In the Matter of)
Pa'ina Hawaii, LLC)
Material License Application)
_____)

Docket No. 30-36974-ML
ASLBP No. 06-843-01-ML

INTERVENOR CONCERNED CITIZENS OF HONOLULU'S
REBUTTAL TO NRC STAFF'S STATEMENT OF POSITION

EXHIBIT 25

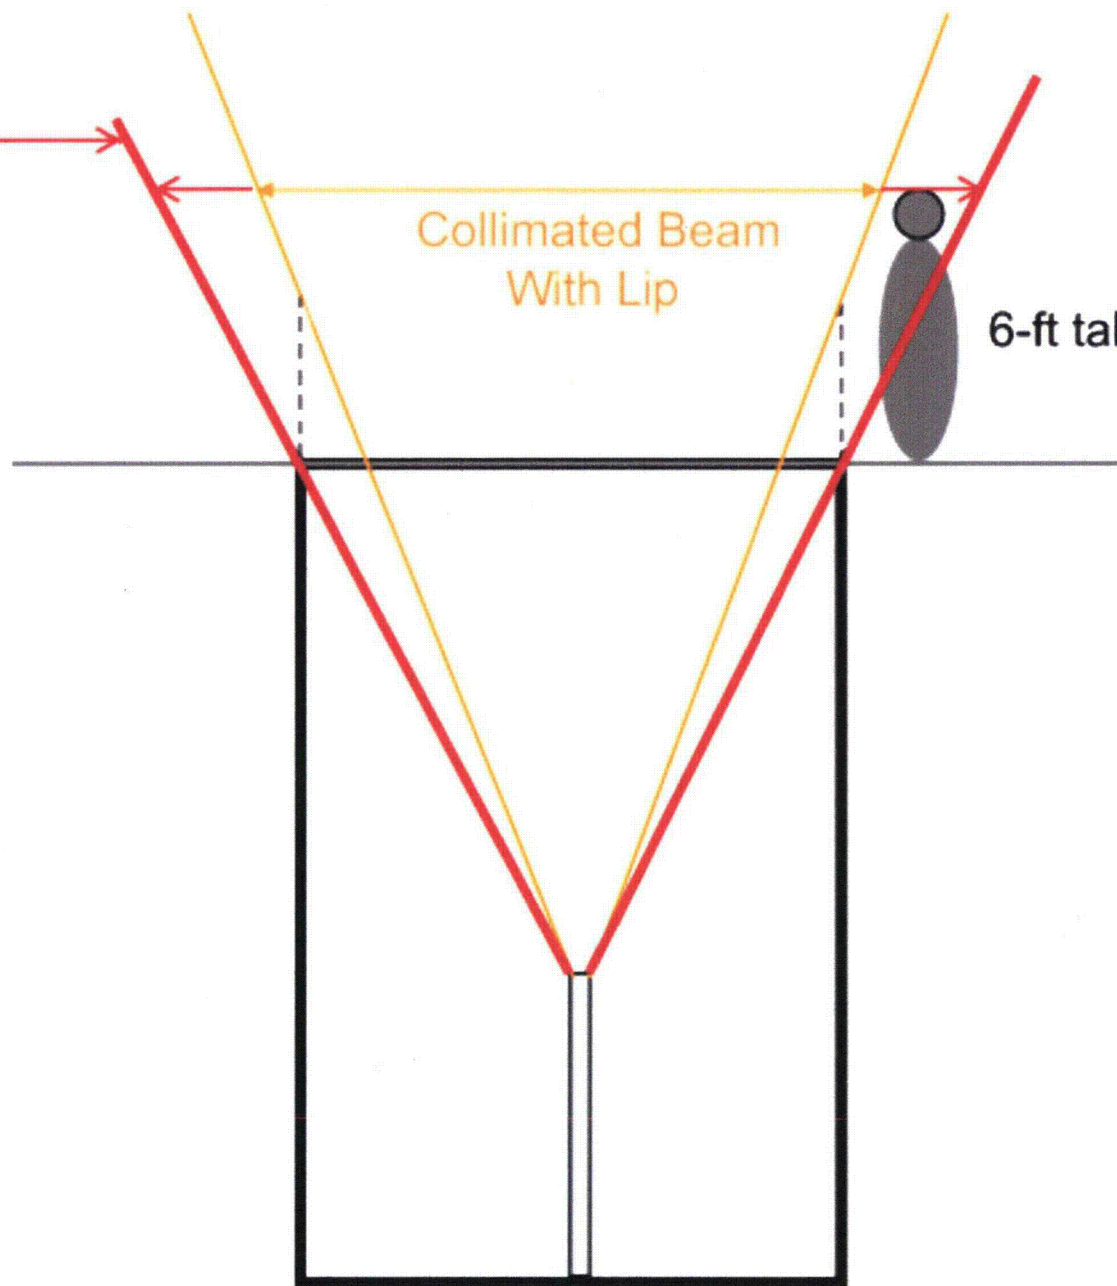
Attached hereto as Exhibit "25" is a modified schematic showing the width of the beam without the irradiator lip. Anyone approaching the pool following an accident would likely be exposed to excessive radiation. My calculations, attached as Exhibit "26," show that, if the shielding water were to drain to the level of the surrounding water table, the dose at floor level would be greater than 14 rem/hr. In only twenty-two minutes, any irradiator personnel on the scene would be subjected to more than the annual occupational dose limit of 5,000 millirem/year. Emergency responders – who, for regulatory purposes, are considered members of the public – would exceed the 100 millirem/year maximum dose in less than 26 seconds.

EXHIBIT 28

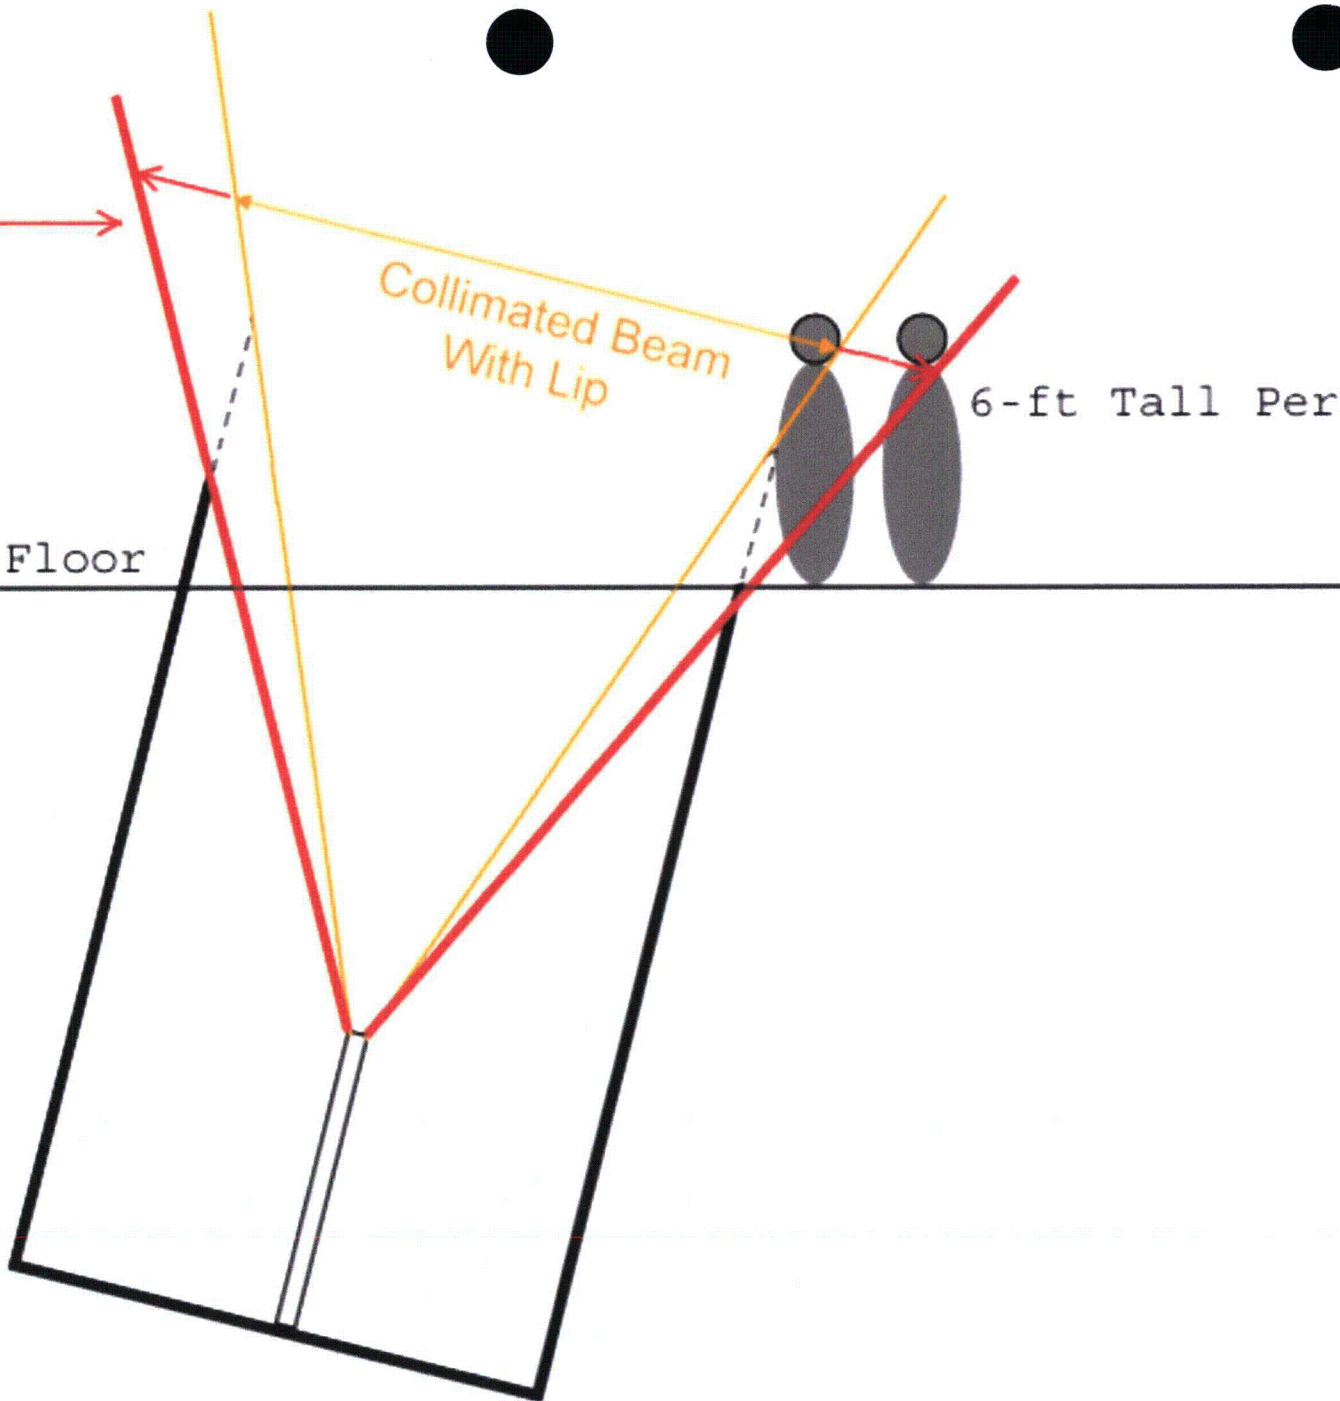
Neither Dr. Durham nor Dr. Stamatakos performed any calculations regarding the potential change in angle of the collimated beam due to tilting of the pool. Moreover, they failed to quantify the potential radiation doses of facility personnel or emergency responders exposed to that modified beam. Accordingly, they have no basis for asserting there is no potential for radiological impact.
